SCC-400  
2.2.1.06  
Cachuma Project

Subject: Submittal of Plan in Accordance with Term 18 of Water Rights Order WR-2019-0148

## **Cachuma Order WR-2019-0148 Term 18 Plan**

Re: National Marine Fisheries Service Comments on U.S. Bureau of Reclamation's Draft Cachuma Order WR-2019-0148 Term 18 Plan

**Figure 1. Decision Tree for Releases from Lake Cachuma to Maintain 1.5 cfs Flow Target in Spill Years with more than 20,000 acre-feet of Spill and First Year after such Spill Years\***

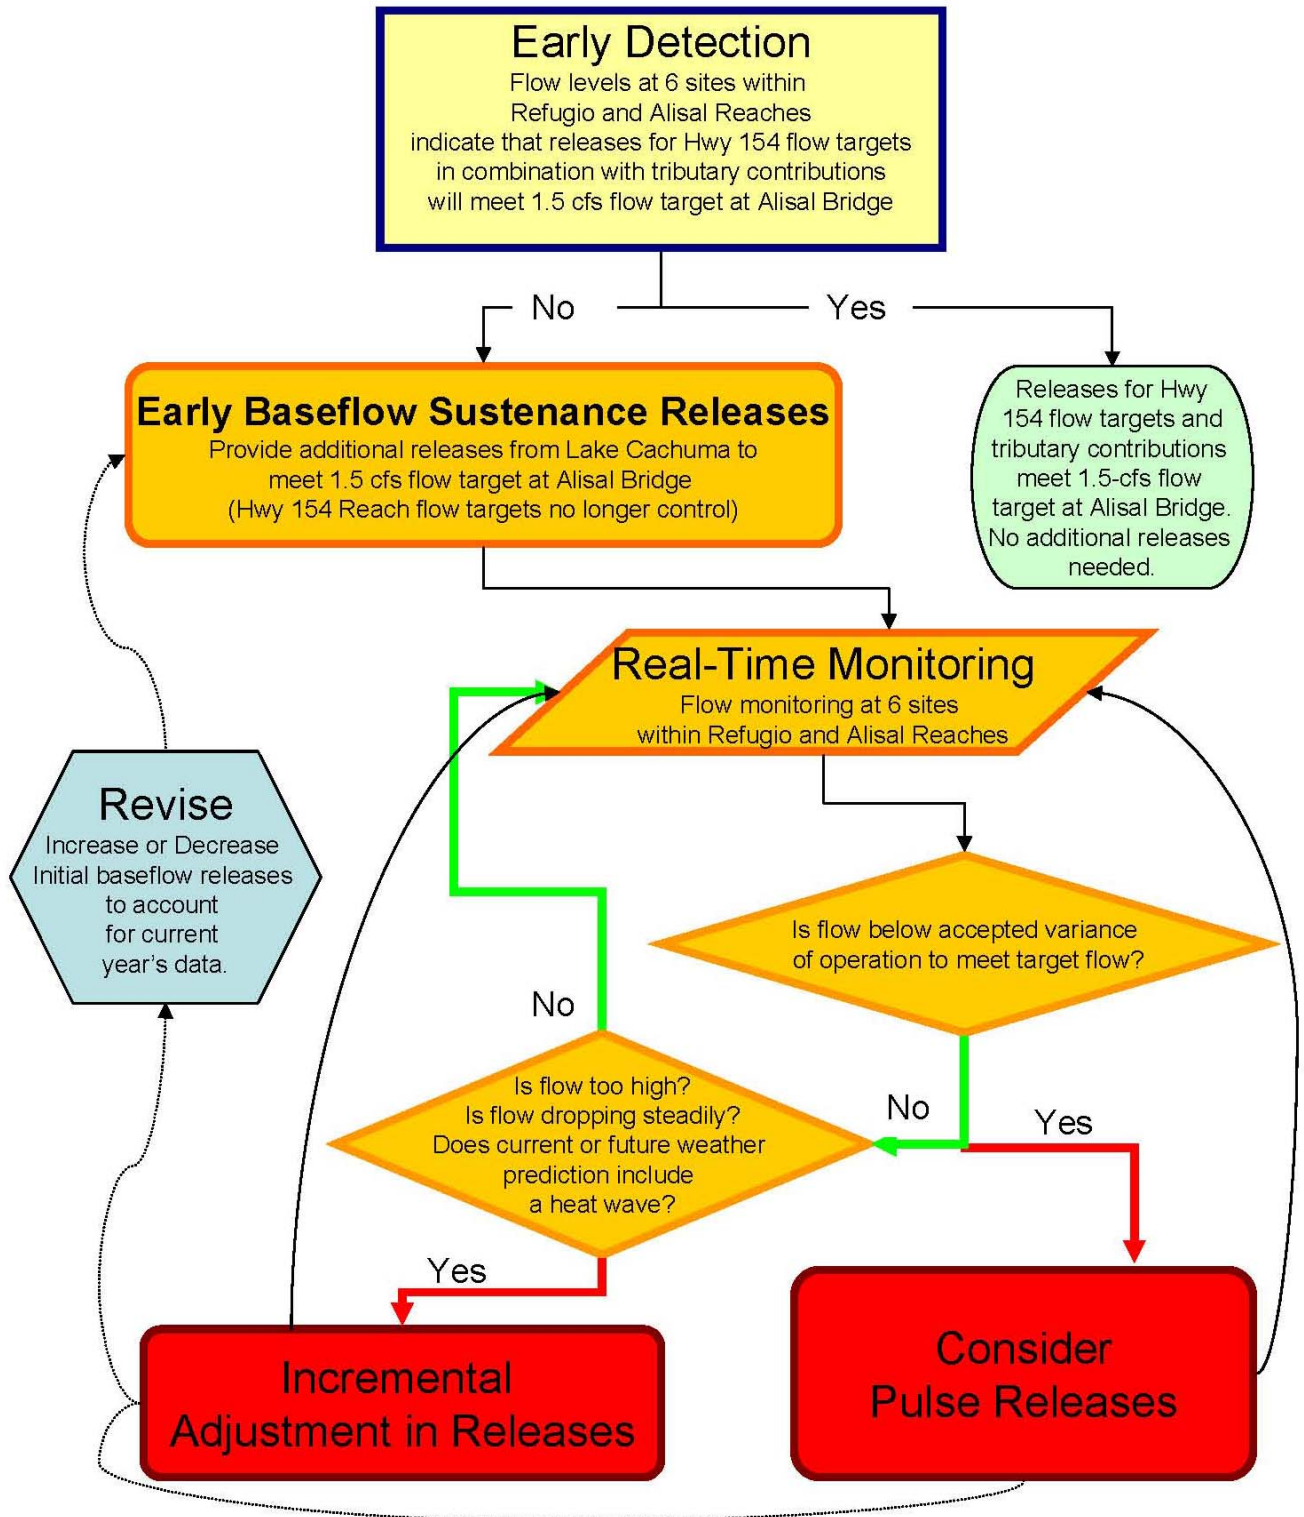
**Commented [NMFS5]:** We suggest including the actual decision tree in the Term 18 Plan, rather than incorporating by reference.
